nature portfolio

Peer Review File

Long-chain anionic surfactants enabling stable perovskite/silicon tandems with greatly suppressed stress corrosion

REVIEWER COMMENTS

Figure R1. AFM topography mapping of perovskite thin films without (referred as control sample) (a) additives, $[C_4mim]^+[C_0SO_4]^-$ (b), $[C_4mim]^+[C_1SO_4]^-$ (c) and $[C_4mim]^+[C_8SO_4]^-$ (d) treated films.

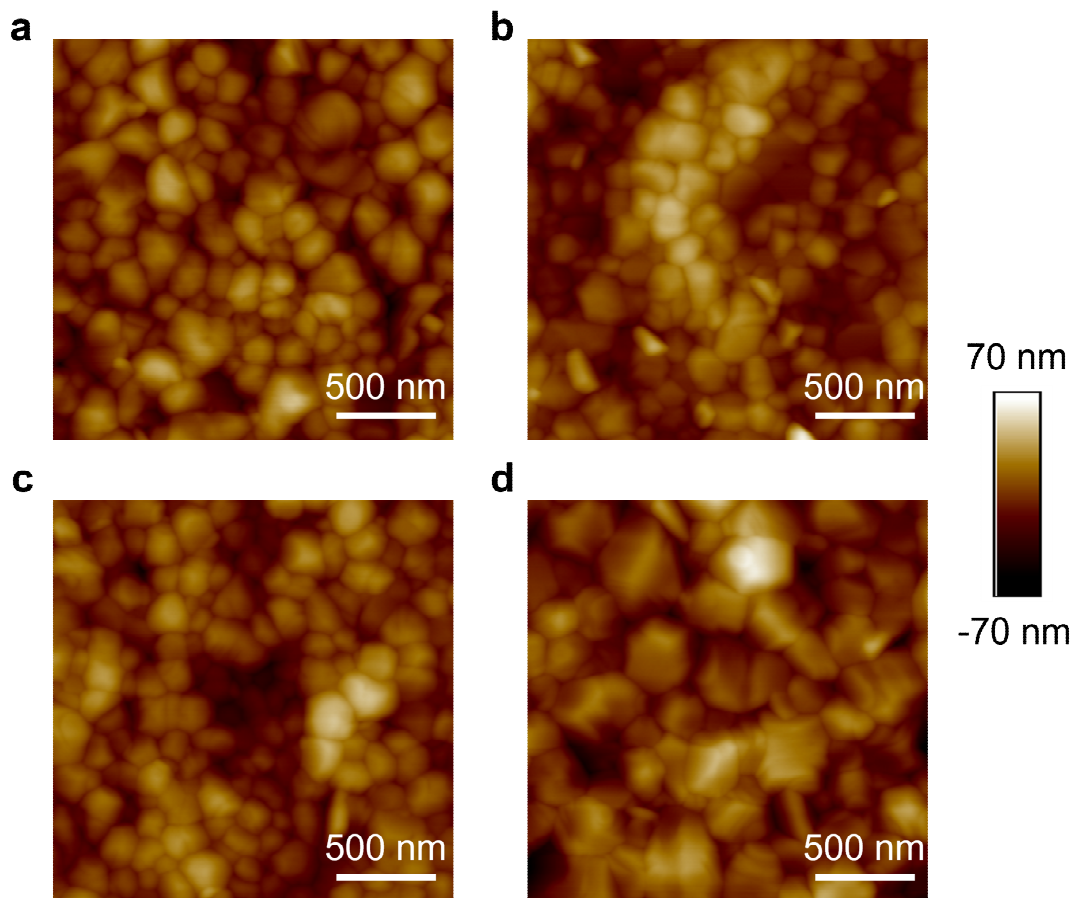
1. **Comment**: It would be better to also provide the corresponding AFM topography mapping of perovskite films in Figure 1a-d.

Thanks for your valuable suggestions. Figure R1 shows the corresponding AFM topography mapping of perovskite films in Figure 1a-d. Compared with the control film, the perovskite films exhibit a slightly decreased grain size after the incorporation of $[C_4mim]^+[C_0SO_4]^-$ and $[C_4mim]^+[C_1SO_4]^-$. On the contrary, the grains became larger for the $[C_4mim]^+[C_8SO_4]^-$–based perovskite film. The enlarged perovskite grain size can also be confirmed by the scanning electron microscopy (SEM) results (Supplementary Fig. 19).

The corresponding AFM topography mapping of perovskite films in Figure 1a-d had been added in Supplementary Fig. 2.

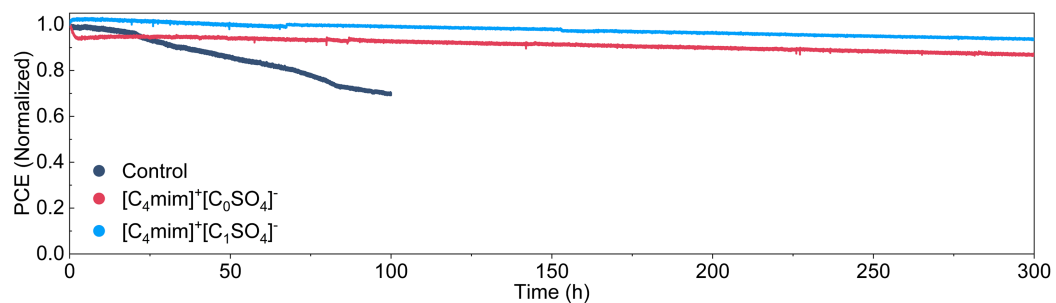
5. **Comment**: As the LASs consisting of $[C_nSO_4]^-$ featuring different alkyl chain lengths induced obvious differences in the perovskite films, I am curious how the solar cells by incorporating different $[C_nSO_4]^-$ would behave?

Thanks for your precious comments and suggestions. We first performed J–V and SPO measurments for the devices based on different $[C_nSO_4]^-$. As shown in <mark>Figure R4</mark>, the PCE improvements were mainly the result of enhanced V_{OC} and FF in LASs-treated devices. The improvement of $[C_4mim]^+[C_8SO_4]^-$-treated devices was the most significant, while the $[C_4mim]^+[C_0SO_4]^-$-treated devices were accompanied with an obvious hysteresis. These differences can be attributed to the different distribution of additives in perovskite films [*Nano Energy 97, 107193 (2022). 10.1016/j.nanoen.2022.107193*].

The effects of the surfactant additives consisting of $[C_nSO_4]^-$ featuring different alkyl chain lengths on device performance and stability had been added in the Supplementary Figs. 33 and 47. The corresponding discussion had been added in the caption of Supplementary Figs. 33 and 47, respectively.

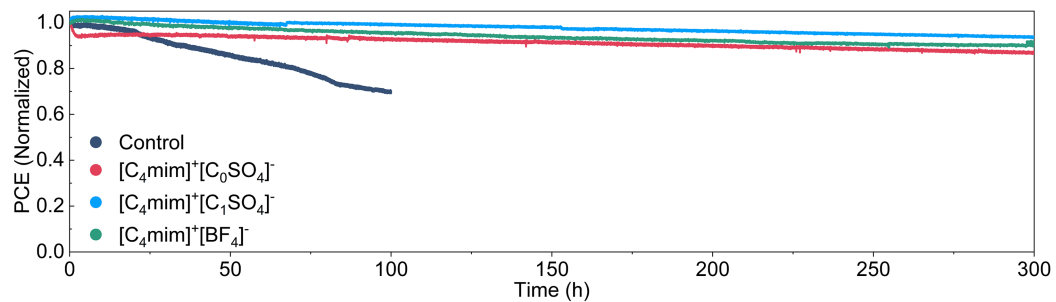
1. **Comment**: This work has performed comprehensive characterisation at both material and device levels and provided sounded and robust data interpretation. However, an important question to be pointed out is the inconsistency between the perovskite film characterisation and the device testing. For perovskite film characterisation, various surfactants with different alkyl chain length (n=0, 1, 8) as well as different anion (BF_4^-) were compared to assess their impact of perovskite film quality. However, only one surfactant $[C_4mim]^+[C_8SO_4]^-$ was tested and reported at the device level. This makes it incomplete to understand the correlation between the film optoelectronic property and the device performance. Hence, it is strongly suggested that all the surfactant molecules are tested at device level. This is particularly important given the fact that the device performance (21%) reported in this work still lags behind that of the state-of-the-art (>24%) with the same bandgap. This raises the question

Thank you for your kind suggestion. The effects of the surfactant additives consisting of $[C_nSO_4]^-$ featuring different alkyl chain lengths as well as $[C_4mim]^+[BF_4]^-$ on device performance had been added in the Figure R8. The PCE improvements were mainly the result of enhanced V_{OC} and FF in various surfactant-treated devices. The improvement of $[C_4mim]^+[C_8SO_4]^-$-treated devices was the most significant, while the $[C_4mim]^+[C_0SO_4]^-$ and $[C_4mim]^+[BF_4]^-$-treated devices were accompanied with an obvious hysteresis. The differences in device performance were mainly attributed to the different distribution of additives in perovskite films.

We also proceed to investigate the stabilities of the complete photovoltaic cells incorporated with different surfactant additives under MPPT (<mark>Figure R9</mark>). For the control device, the PCE quickly decreased to around 70% after roughly 100 hours of aging. By comparison, for the $[C_4mim]^+[C_0SO_4]^-$, $[C_4mim]^+[C_1SO_4]^-$ and $[C_4mim]^+[BF_4]^-$-treated cells, we observed the roughly 16%, 7% and 10% drop in the PCEs for 300 hours ageing. Moreover, the early-time 'burn-in' was observed in the $[C_4mim]^+[C_0SO_4]^-$-treated cell during the MPPT measurement.

The effects of the surfactant additives consisting of $[C_nSO_4]^-$ featuring different alkyl chain lengths as well as $[C_4mim]^+[BF_4]^-$ on device performance and stability had been added in the Supplementary Figs. 33 and 47.

The discussion: "Compared with control devices, the device statistics corroborated that the PCE improvements were mainly the result of enhanced V_{OC} and FF in the treated devices. The improvement of $[C_4mim]^+[C_8SO_4]^-$-treated devices is the most significant, while the $[C_4mim]^+[C_0SO_4]^-$ and $[C_4mim]^+[BF_4]^-$-treated devices are accompanied with an obvious hysteresis. The differences in device performance are likely attributed to the different distribution of additives in perovskite films." had been added in the caption of Supplementary Figs. 33.

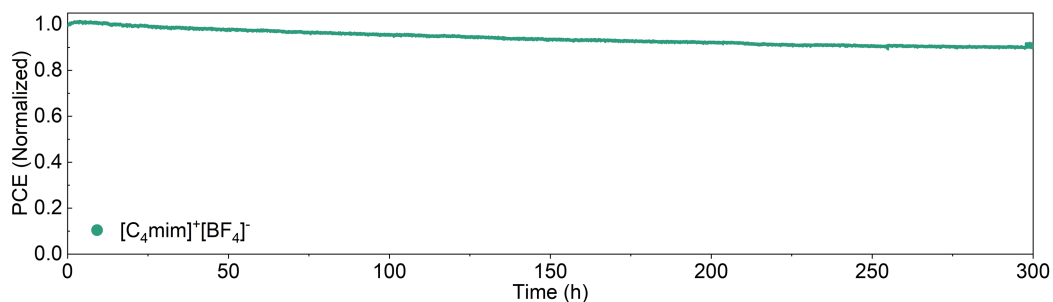
2. **Comment**: Another technical question to answer is that the authors also observed increased YMs for short-chain $[C_4mim]^+[BF_4]^-$ additive. This seems to be contradictory to the report by Bai, S. et al [Ref. 30, Planar perovskite solar cells with long-term stability using ionic liquid additives. Nature 571, 245-250 (2019).], where $[C_4mim]^+[BF_4]^-$ was found to improve the PSC efficiency and stability. Therefore, in this work, the authors are suggested to also test the device performance for the PSC treated with $[C_4mim]^+[BF_4]^-$ for comparison.

Thanks for the helpful comments which guide us to make this point clearer. The J–V and SPO results of the device based on $[C_4mim]^+[BF_4]^-$ are shown in Figure R10 and Figure R11, respectively. The $[C_4mim]^+[BF_4]^-$-treated devices exhibited an increased PCE due to the enhanced V_{OC} and FF compared with the control devices (Figure R10) but showed a decreased PCE compared with the target samples. Meanwhile, we also observed an increased hysteresis for the $[C_4mim]^+[BF_4]^-$-treated device, which can be explained by the accumulation of $[BF_4]^-$ at the bottom of the perovskite film [*Nature 571, 245-250 (2019).10.1038/s41586-019-1357-2*]. It is well known that both defect passivation and stress reduction can synergistically contribute to the device performance. To further quantify the long-term stability, we also performed MPP tracking experiment under simulated full-sun irradiance (Figure R12). The $[C_4mim]^+[BF_4]^-$-treated device showed a better stability compared to the control device, but was less stable than the $[C_4mim]^+[C_8SO_4]^-$-treated device. The improved stability compared to the control device is due to more effective defect passivation in the

[C$_4$mim]$^+$[BF$_4$]$^-$-treated device, while the poor stability compared to the [C$_4$mim]$^+$[C$_8$SO$_4$]$^-$-treated device is caused by the increased stress in the [C$_4$mim]$^+$[BF$_4$]$^-$-treated device.

The results of J–V, SPO and MPPT measurements had been added in Supplementary Figs. 33 and 47. The corresponding discussion had been added in the caption of Supplementary Figs. 33 and 47, respectively.
